D-49 Transportation Center
Traffic Impact Study
(LSC #S214340)
PCD File No. U-221
May 9, 2022

LSC Responses to TIS Redline Comments

Figure 2
Proposed Site and Access Plan
 D49 Transportation Facility - Falcon (LSC #S214340)

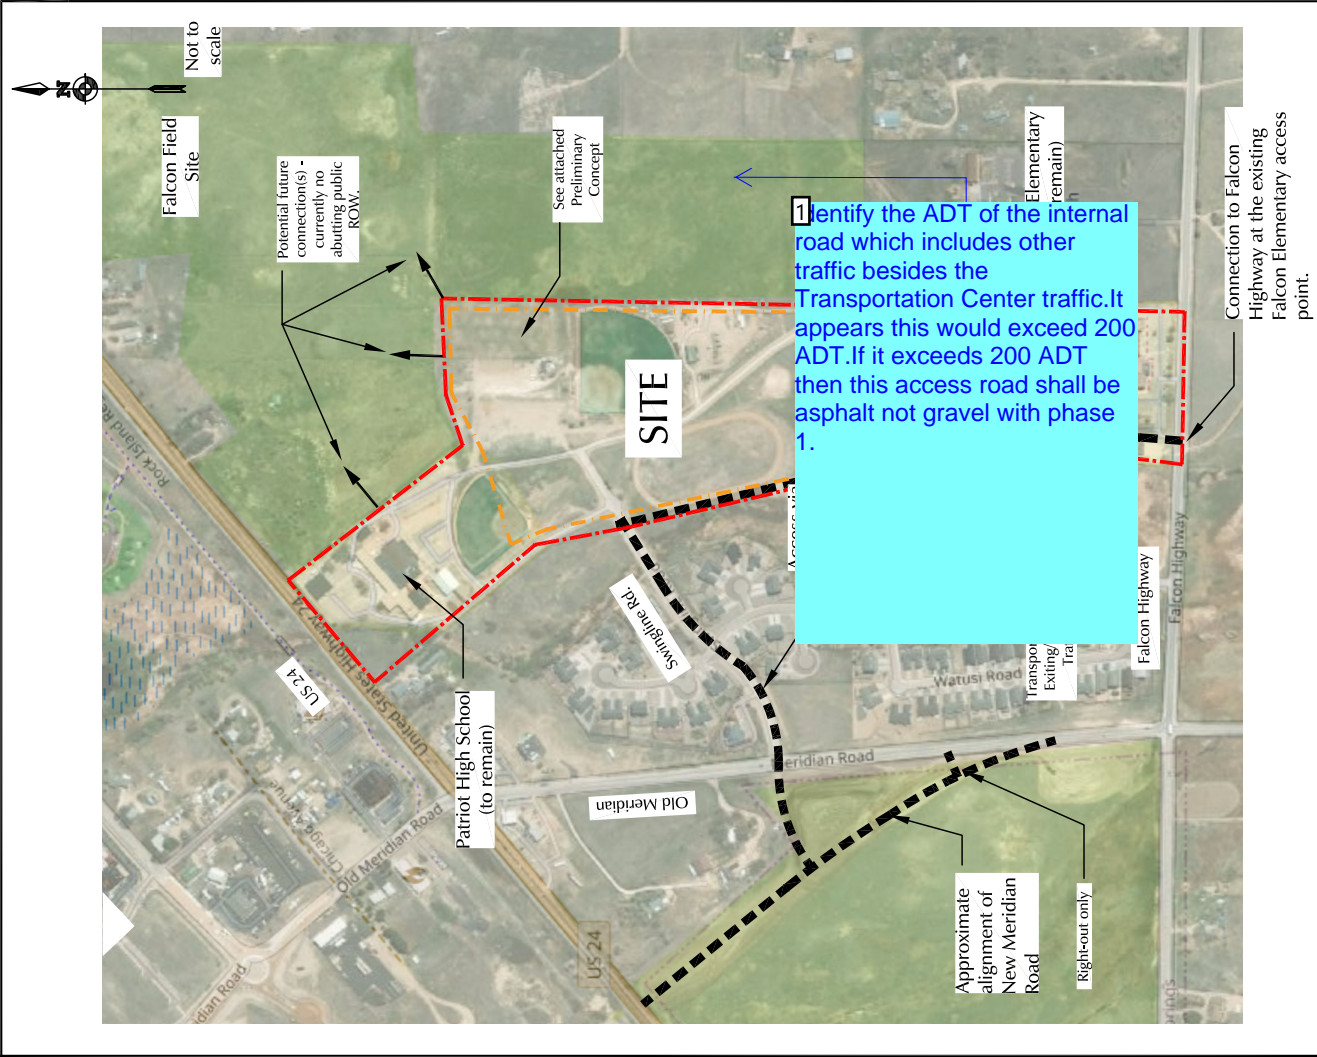
Identify the ADT of the internal road which includes other traffic besides the Transportation Center traffic. It appears this would exceed 200 ADT. If it exceeds 200 ADT then this access road shall be asphalt not gravel with phase 1.

LSC Response: The updated report addresses this comment.
